**USA  
RECALL CAMPAIGN**

**REF. NO. C24100080**

**REPLACEMENT OF BRAKE FLUID  
RESERVOIR CAP**

***F12berlinetta***

Page Location to Apply  
New Adhesive Sticker

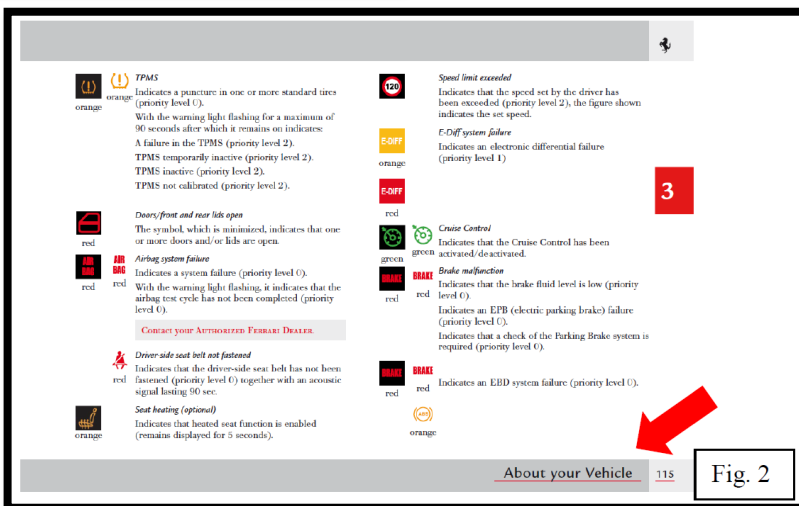
Please find below the proper location and instructions on how to insert the provided sticker into the Owner's Manual (PN: 079641778)

The sticker must be placed on the page shown above in the Owner's Manual. This page is located in the **"About Your Vehicle"** section where the warning lights on the instrument panel are described. Please be sure to attach it to the page with the **"Low Brake Fluid"** description as shown above in Fig. 2.

Once you locate the proper page, remove the adhesive protector off of the back of the sticker. Ensure there is no residue or other particles on the page that may inhibit the longevity of adhesion to the page. Place the sticker to allow the bottom of the sticker to lay directly above the gray margin at the bottom of the page that contains the text **"About your Vehicle"**.
